REMARKS

In the Drawings

Fig. 4

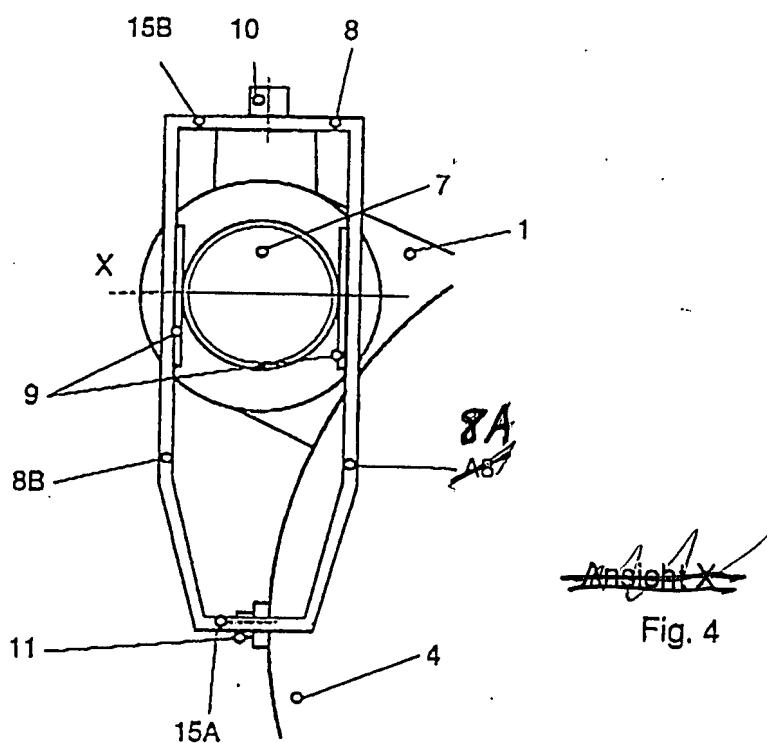
The German wording near Fig. 4 is unnecessary and has been deleted. Also, the small circle at the end of the leader line for reference numeral 13 is believed misleading and has been deleted since it does not designate a pin or other pivotal connection of the rocker arm 8 to bolt 7 and merely designates a moveable fulcrum for pivoting the rocker arm 8 on bolt 7. As an editorial matter, the other small circles provided by the draftsperson at the ends of the leader lines have also been eliminated in the Replacement Sheets of drawings since they too may be somewhat misleading.
